STATE OF MAINE
DEPARTMENT OF TRANSPORTATION
16 STATE HOUSE STATION
AUGUSTA, MAINE 04333-0016

November 9, 2023
Subject: Bridge Construction
State WIN: 025631.01
Location: **Medway**
Amendment No. 3

SPECIAL PROVISION
SECTION 502
STRUCTURAL CONCRETE
(Precast Deck Panels)

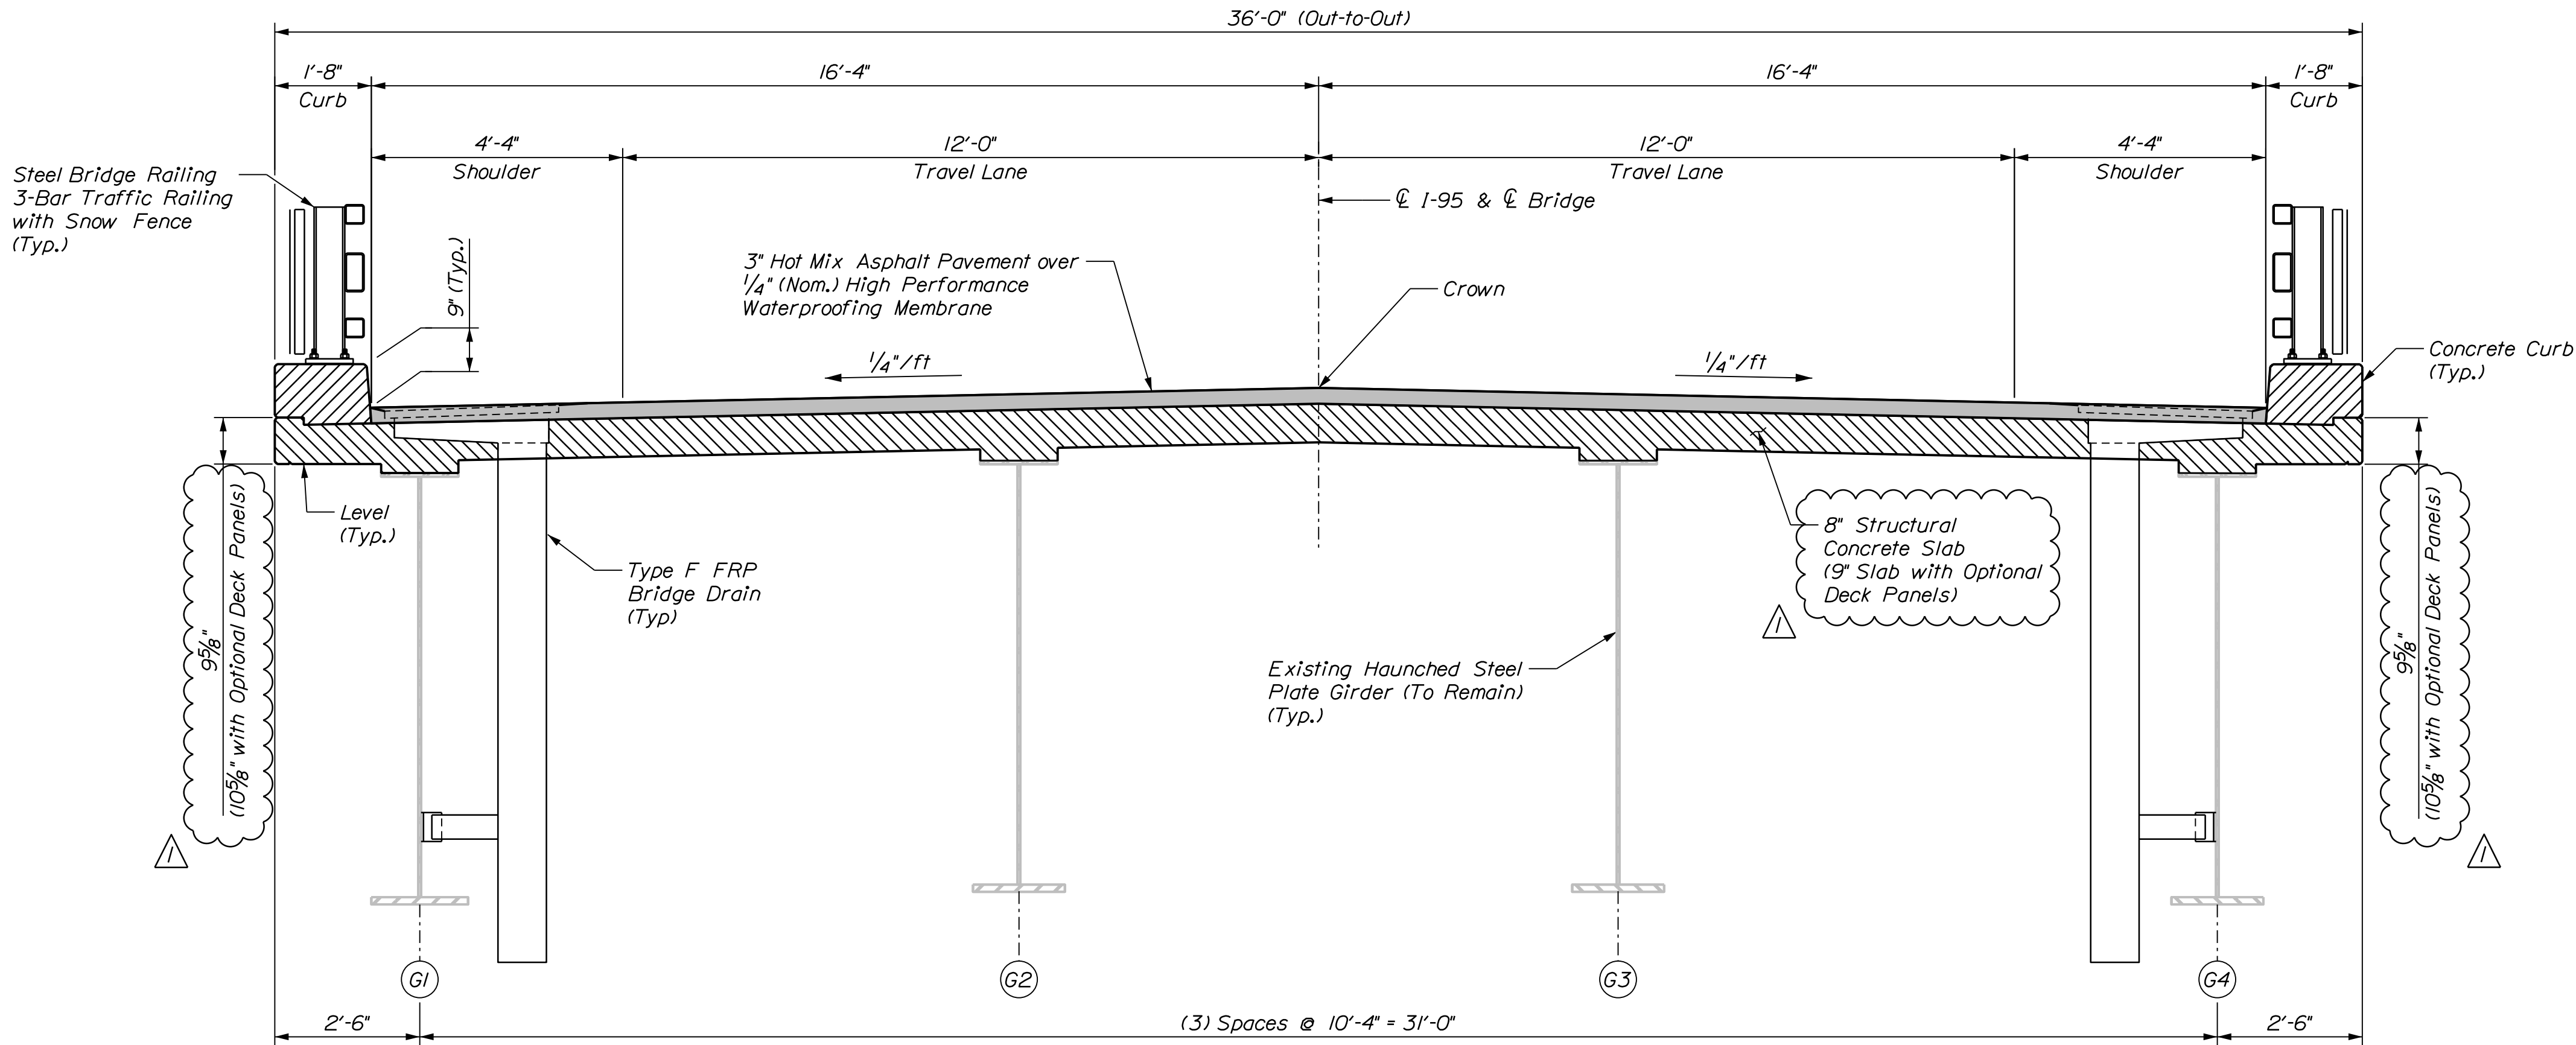
ADD the attached Special Provision Section 502 Structural Concrete (Precast Deck Panels), dated November 6, 2023 (1 page).

Precast deck panels shall be manufactured in conformity with the following tolerances:

Depth	-1/8 in, + 1/4 in
Width	-0, + 1/4 in
Length	± 1/4 in
Sweep	1/4 in (deviation from line parallel to centerline)
Variation from specified plan end squareness or skew	1/2 in max. Difference in diagonal meas.
Location of strand group perpendicular to plane of panel	+0, -1/4 in Meas. from bottom of slab
Location of individual strand perpendicular to plane of panel	± 1/4 in
Location of individual strand parallel to plane of panel	± 1/2 in
Strand projection from end	- 1/4 in, + 3/4 in
Bowing	± 1/4 in
Threaded jack inserts	± 1/4 in longitudinally and transversely

TRANSVERSE SECTION
 I-95 Northbound shown.
 I-95 Southbound opposite hand.

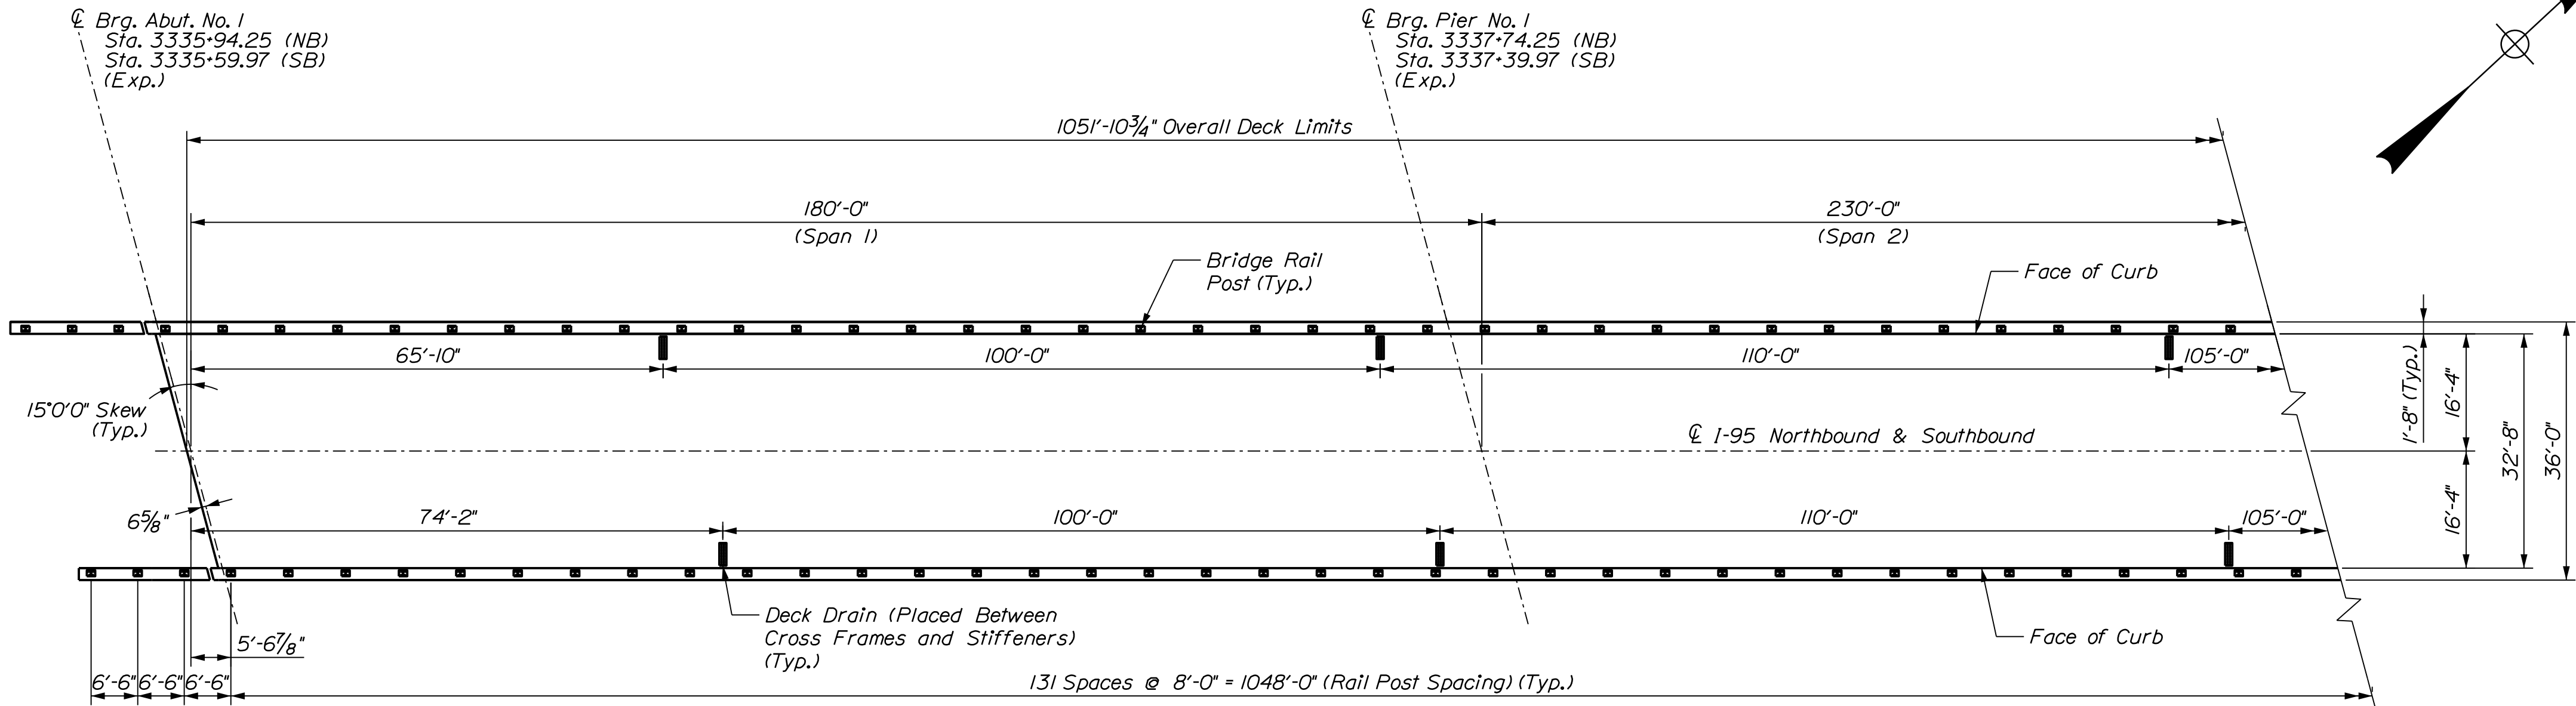
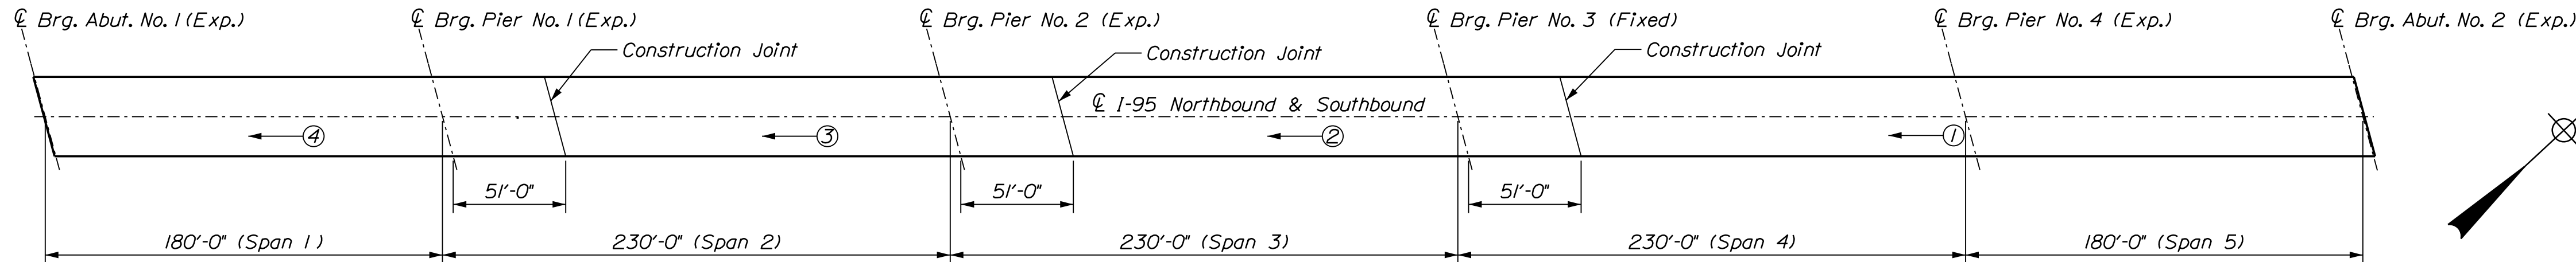
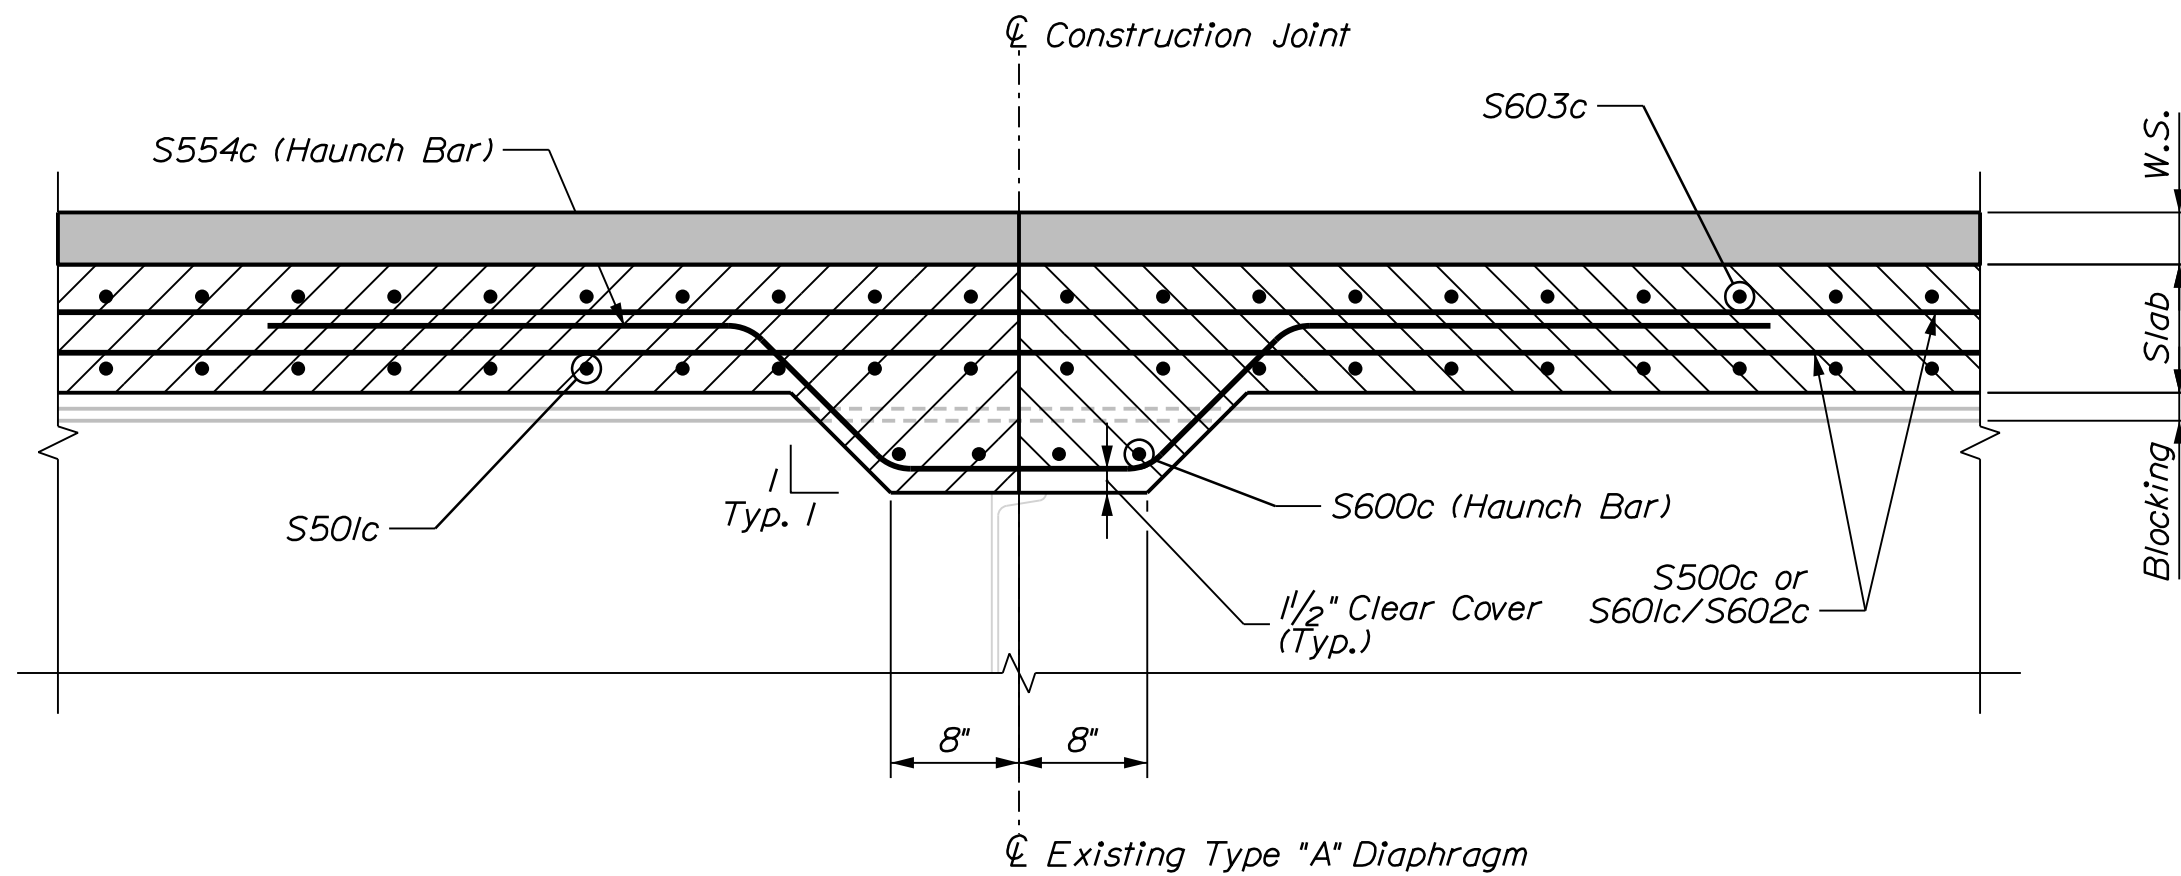
REMOVE Sheet Number 130 of 168, TRANSVERSE SECTION and **REPLACE** dated 10/3/2023 with the attached Sheet Number 130 of 168, TRANSVERSE SECTION and **REPLACE** dated 11/7/2023.

5. At the Contractor's option, Precast Concrete Deck Panels may be used in place of full depth cast-in-place deck slab, in accordance with Special Provision Section 502, Structural Concrete - Precast Deck Panels, and in accordance with the Standard Details. If used, the total slab thickness shall increase to 9 inches.

6. Payment for reinforcing steel fabricated, delivered, and placed in the cast-in-place portion of the structural concrete slab, sidewalk, and curb will be considered incidental to the appropriate 502 Pay Items. If Contractor opts to use Precast Concrete Deck Panels, Contractor is responsible for revising the Reinforcement Schedule, including updates to bar dimensions that are impacted by the increase in total deck thickness.

7. The centerline elevations in the 1-95 profiles and the Bottom of Slab elevations are based on an 8 inch deck. If Precast Concrete Deck Panels are used, all adjustments to roadway grades and other elevations in the Plans to account for the additional deck thickness shall be the responsibility of the Contractor, and shall be submitted to the Department for review as Working Drawings.

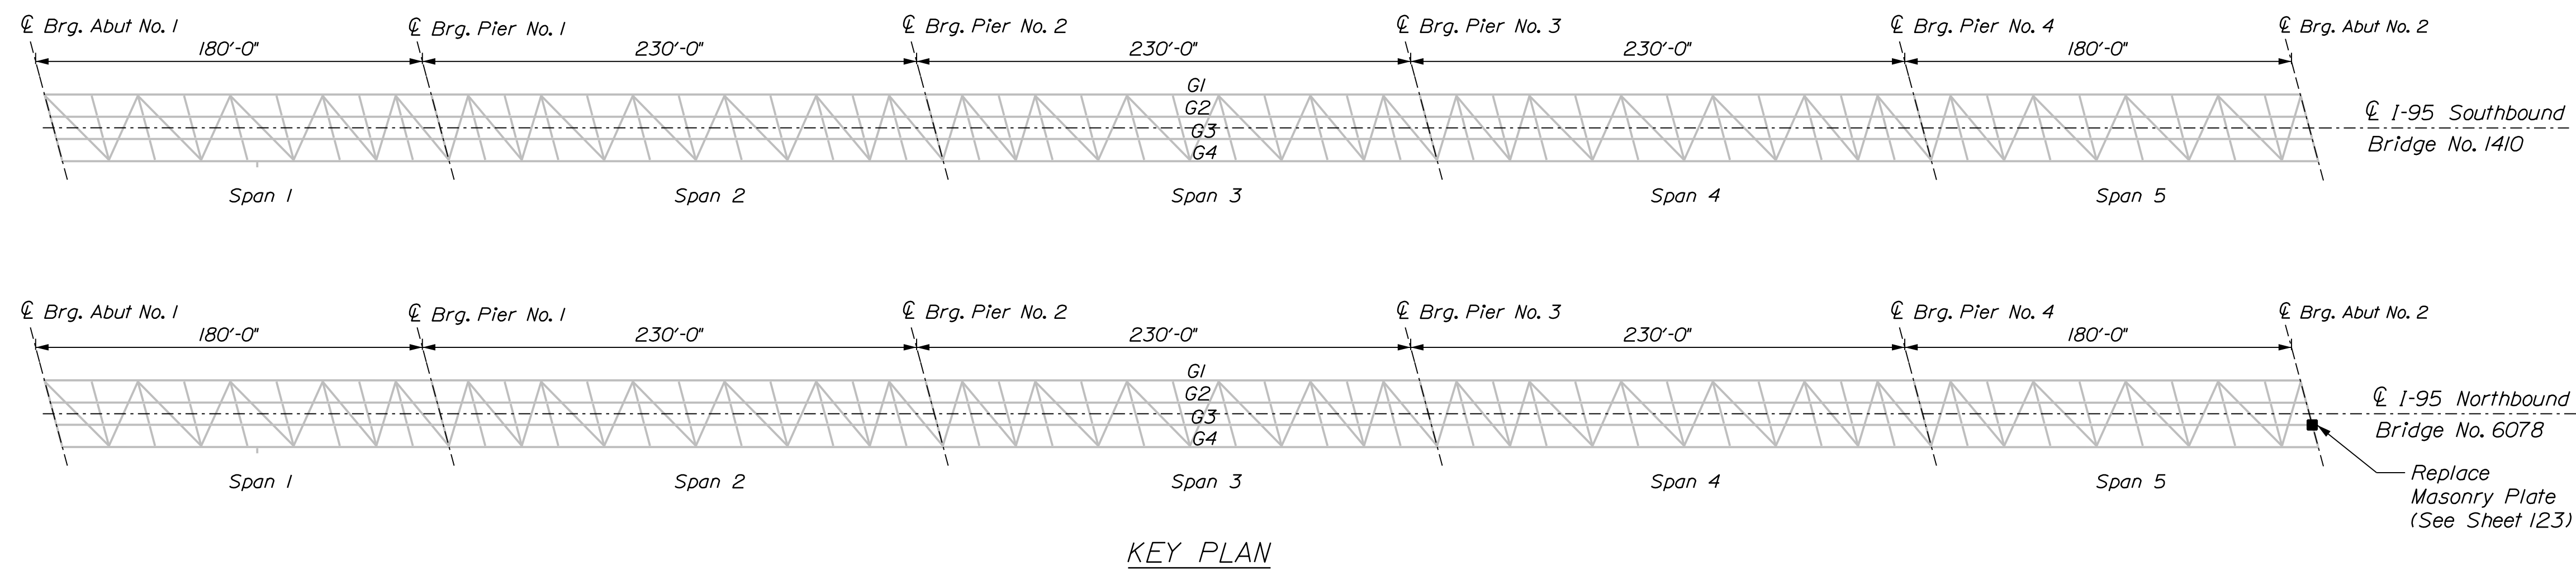
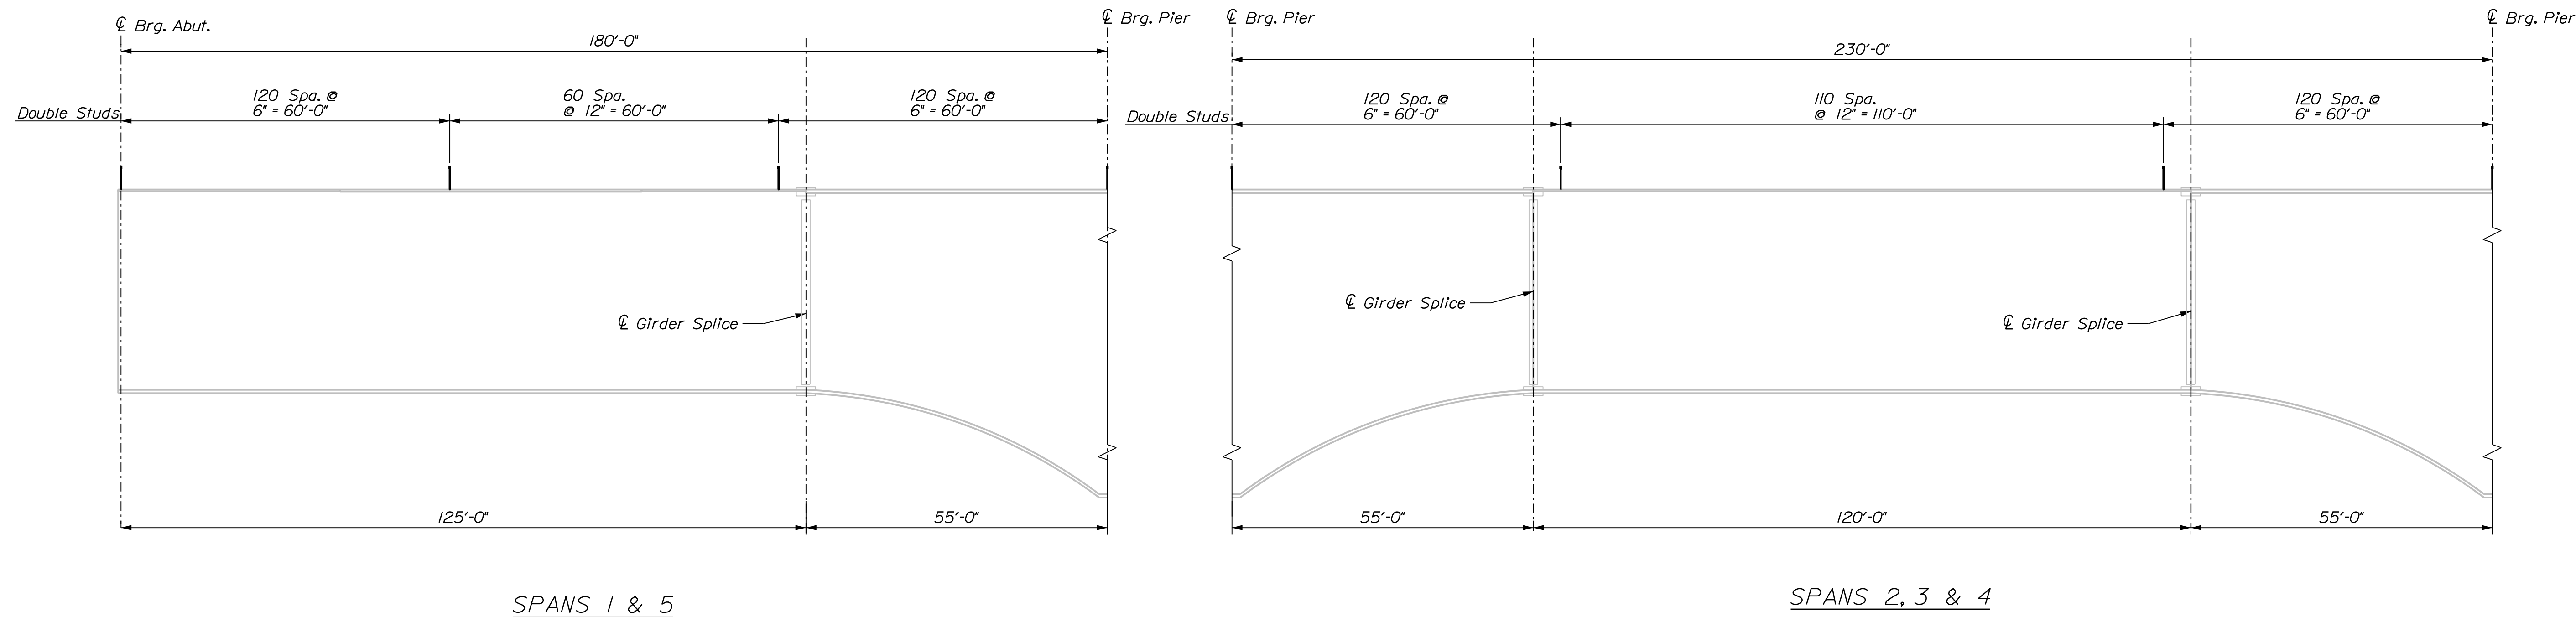
REMOVE Sheet Number 124 of 168, KEY PLAN & SHEAR CONNECTOR LAYOUT dated 10/3/2023 and **REPLACE** with the attached Sheet Number 124 of 168, KEY PLAN & SHEAR CONNECTOR LAYOUT dated 11/7/2023.

4. If Precast Deck Panels are used to construct the superstructure slab, the heads of the shear connectors shall extend a minimum of 1 inch above the top of the panels.
